Comments received on September 17, 2013 from US Marine Corps Base Hawaii

FIGURE 6-7

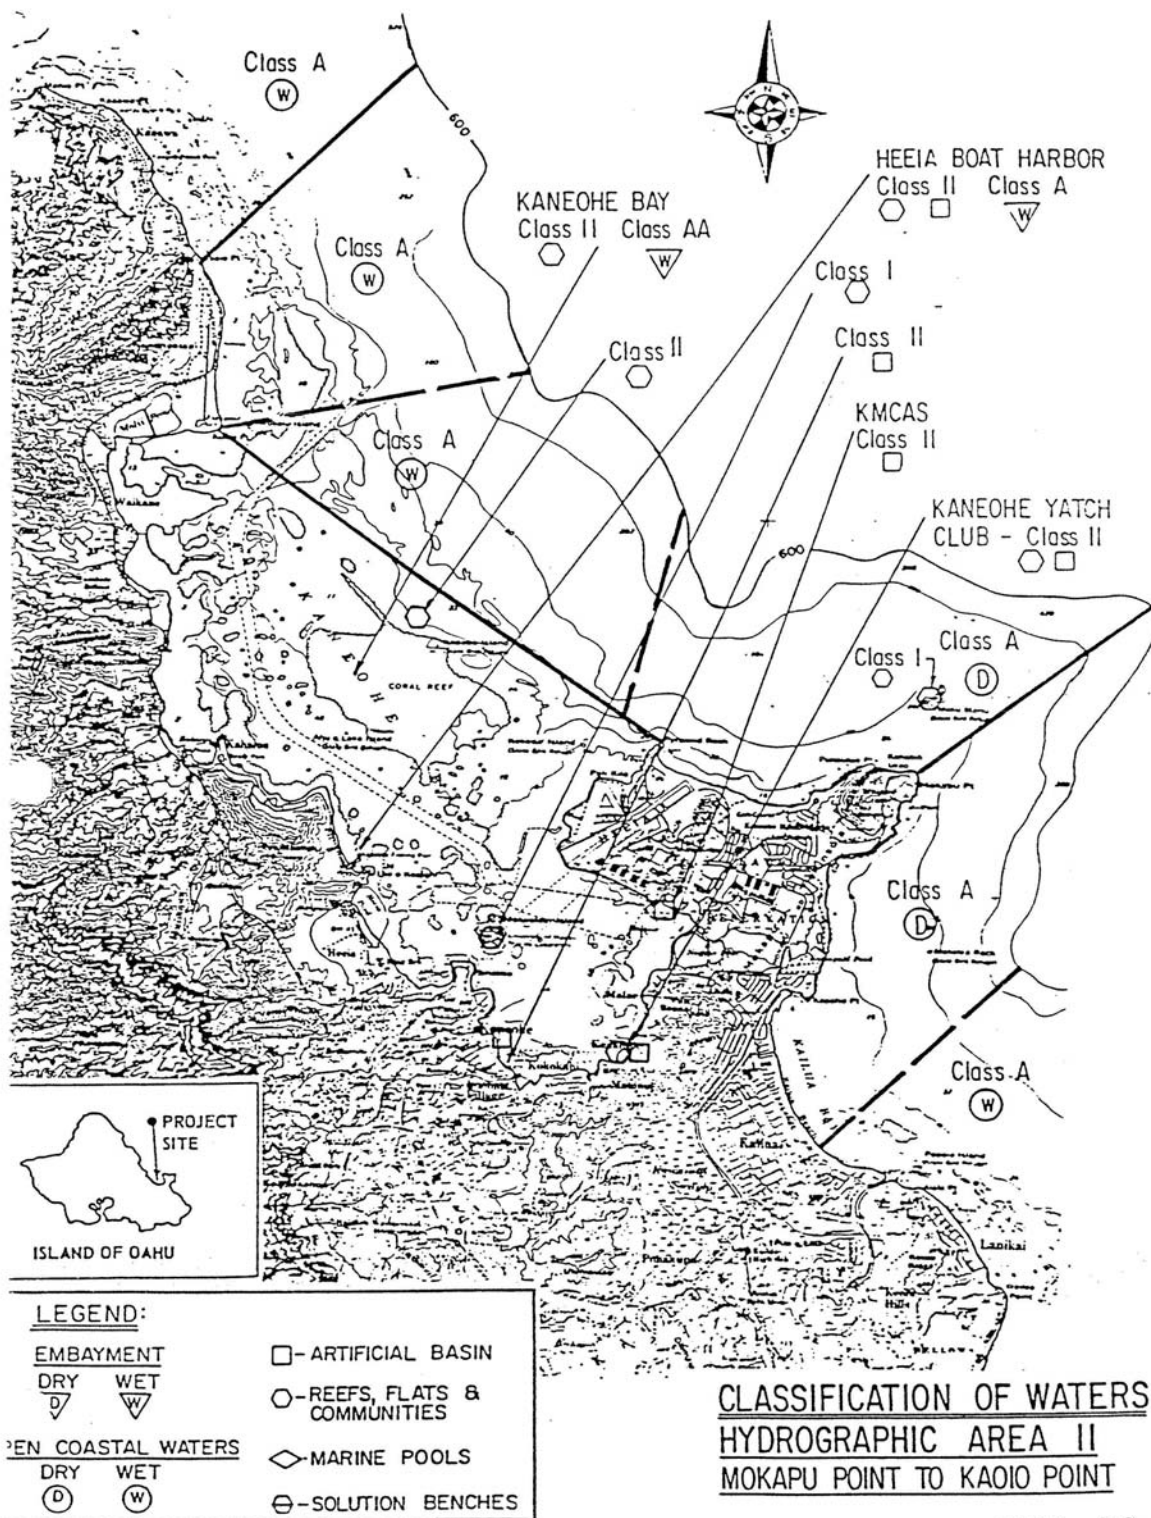
9. Can DOH provide documentation or published data which shows that the shoreline area for this outfall is within a coastal region which receives less than three million gallons per day of fresh water discharge per shoreline mile which would substantiate the use of the "Dry" criteria.

Response: Please see attached Figure 6-7, Classification of Waters Hydrographic Area II Mokapu Point to Kaoio Point, obtained from the Water Quality Management Plan for the City and County of Honolulu dated November 23, 2001.
